Response to U.S. EPR Design Certification Application RAI No. 380, Supplement 3

Request for Additional Information No. 380(4506), Supplement 3, Revision 0

U.S. EPR Standard Design Certification

SRP Section: 09.01.02 - New and Spent Fuel Storage

Figure 6-1

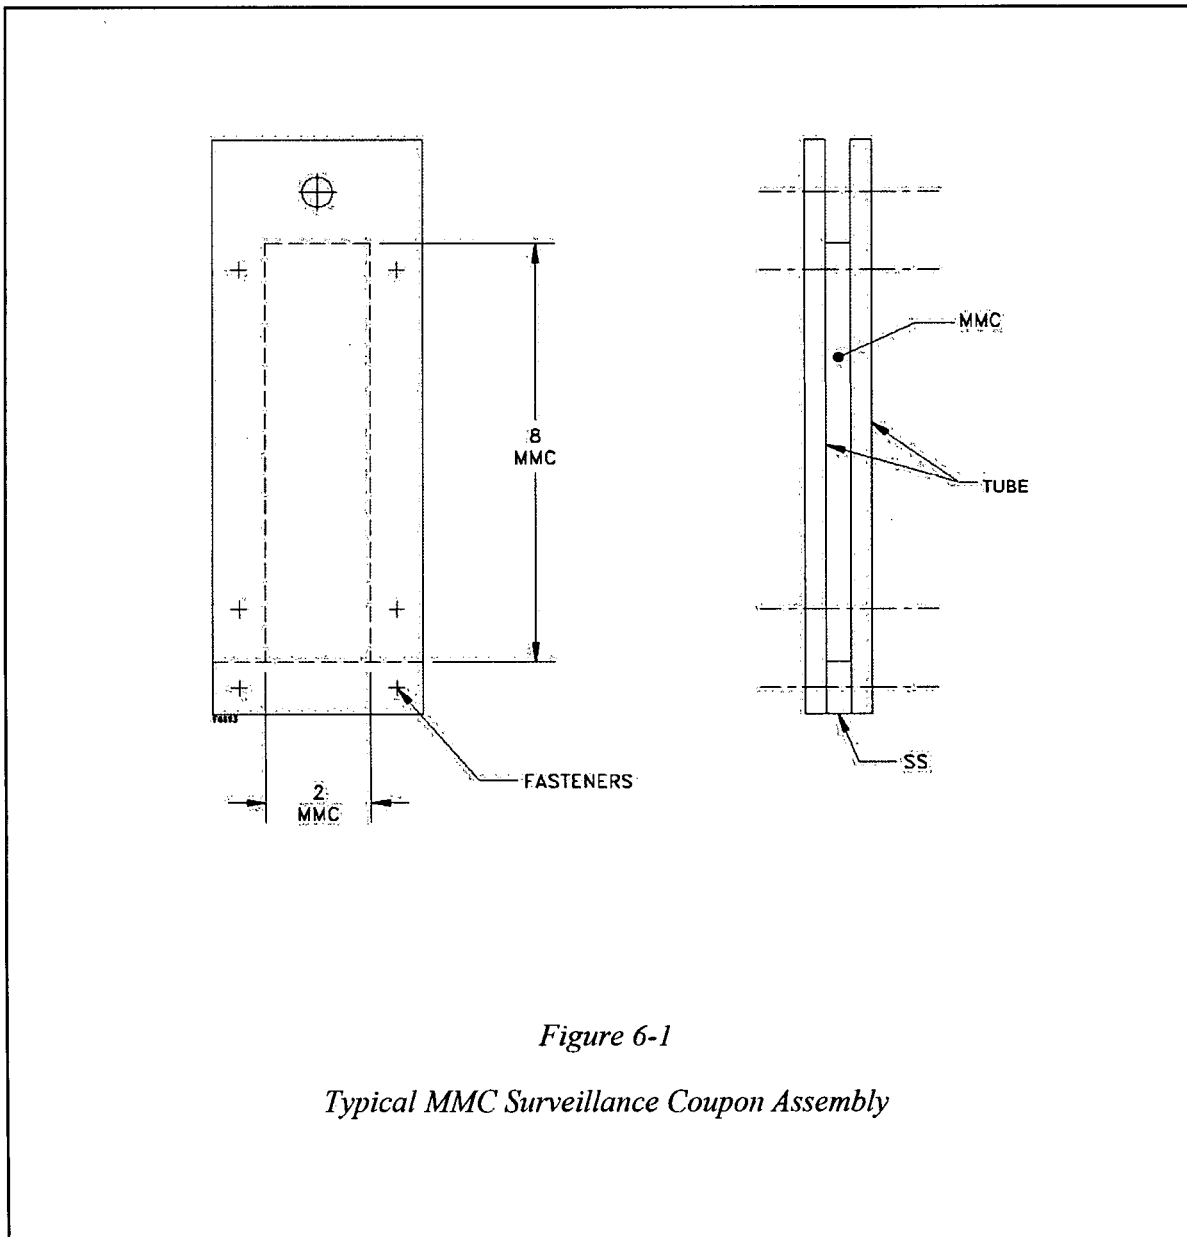
1. Discuss the minimization of the potential for localized corrosion, particularly pitting, of the MMC due to trace contaminants or contaminant particles (either on the surface or in the bulk of the material) in the MMC material. Discuss the control of contaminant particles through the design specification.
2. Described the testing program for the crevice corrosion testing and galvanic corrosion (as has been done with other materials for this service), or provide technical justification to demonstrate that crevice and galvanic corrosion will not occur.

AREVA Technical Report TN-Rack.0101, Revision 0, Sections 6.2.2, 6.4.1, 6.4.2.1.2, 6.4.2.1.4, and 6.4.4 will be revised as described in the response and indicated on the enclosed markup. AREVA Technical Report TN-Rack.0101, Revision 0, Figure 6-1 will be added as described in the response and indicated on the enclosed markup.
